# Access Compliance Report

## Public Rights-of-Way

### (Curb Ramps)

Intersection ID: 48952	Main Street: BREVERA_CR	Cross Street: BONROI_AV	Location:	N
ADA ID: DC1A7C628213	Ramp Type: Perp	Initial Pass/Fail: Fail	Overall Compliance: No	Severity Score: 21.25
Codes/Mitigation Info/Possible Solution		Field Measurements/Component Compliance

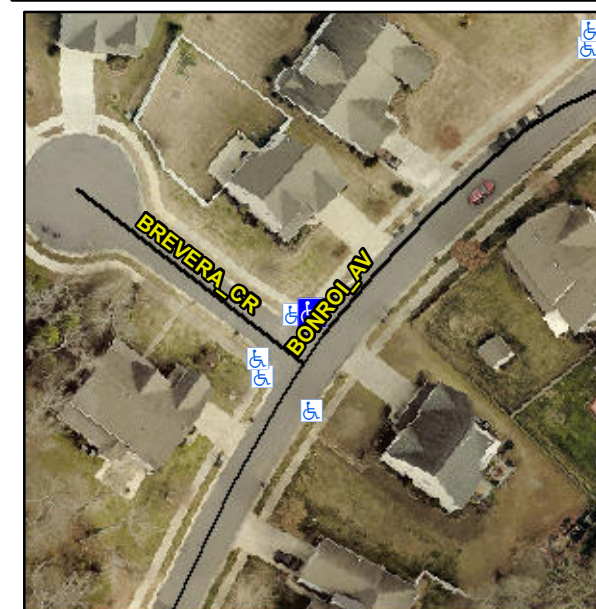
**Not Found, R304.5.1, R304.2.2**

Compliance	Description	Data	Compliance	Description	Data
N/A	Ramp Length (in)	47.0	No	Ramp Slope (%)	8.5
No	Ramp Width (in)	47.5	Yes	Ramp XSlope (%)	0.1
N/A	Flare Type LT	N/A	N/A	Flare Type RT	N/A
N/A	Flare Slope LT (%)	N/A	N/A	Flare Slope RT (%)	N/A
N/A	Flare Traversable LT?	N/A	N/A	Flare Traversable RT?	N/A
N/A	Landing Length (in)	N/A	N/A	DWS Provided?	N/A
N/A	Landing Width (in)	N/A	N/A	DWS Contrast?	N/A
N/A	Landing Slope (%)	N/A	N/A	DWS Length (in)	N/A
N/A	Landing X Slope (%)	N/A	N/A	DWS Full Width?	N/A
N/A	Landing Curb? (Y/N)	N/A	N/A	DWS Offset (in)	N/A
N/A	Shared Landing?	N/A			
N/A	Gutter Ponding?	N/A	N/A	Gutter Slope (%)	N/A
N/A	Gutter Lip Ht (in)	N/A	N/A	Gutter X Slope (%)	N/A
N/A	Painted X Walk1?	No	N/A	Painted X Walk2?	N/A
	X Walk 1 Direction	To SE		X Walk 2 Direction	N/A
N/A	X Walk 1 Width (in)	N/A	N/A	X Walk 2 Width (in)	N/A
	X Walk 1 Slope (%)	1.3		X Walk 2 Slope (%)	N/A
	X Walk 1 X Slope (%)	0.7		X Walk 2 X Slope (%)	N/A

**Remove & Replace Entire Ramp.**
